UNITED STATES
NUCLEAR REGULATORY COMMISSION
WASHINGTON, D. C. 20555

WMUR:LWR
Docket No. 40-4492

FEDERAL-AMERICAN PARTNERS
REQUEST FOR ADDITIONAL INFORMATION
ON SEEPAGE EVALUATIONS

Fig. 4.1. Mill Water-Balance Diagram for 1.82×10^6 kg/day (2000 tons/day) Ore Throughput

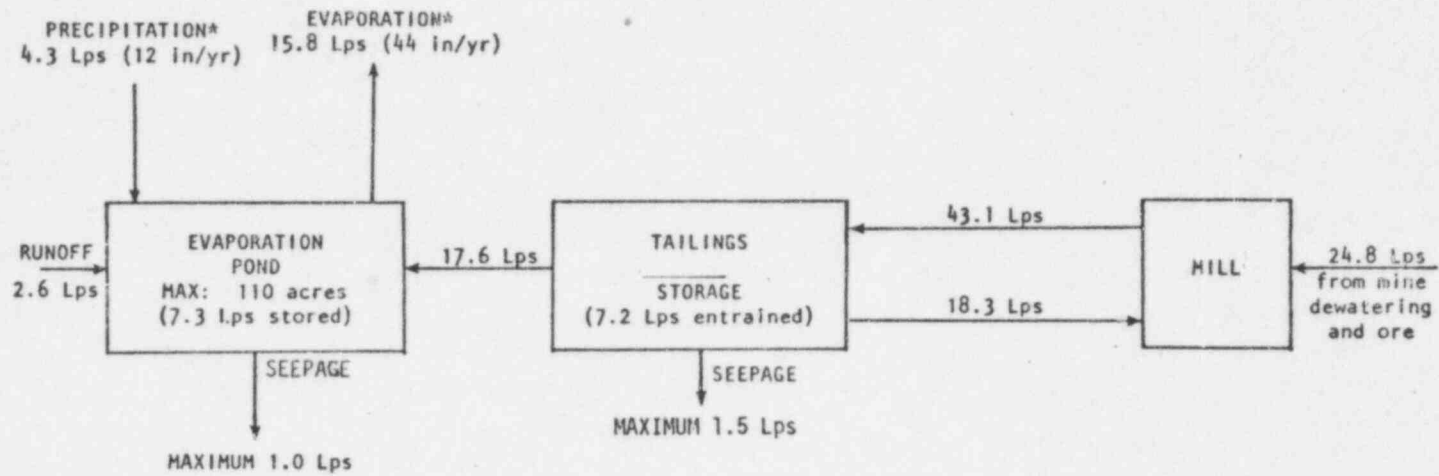
11. Provide a water balance diagram for your existing facility. (See attachment 1 for example.)
 12. No information on thickness, depths or hydrostratigraphic units from which water samples were extracted was included in your seepage investigation report. Therefore, we assume that the data presented are averages of the concentrations contributed to the drill hole by individual hydrostratigraphic units. Under these circumstances, it is probable that the values reported in your seepage
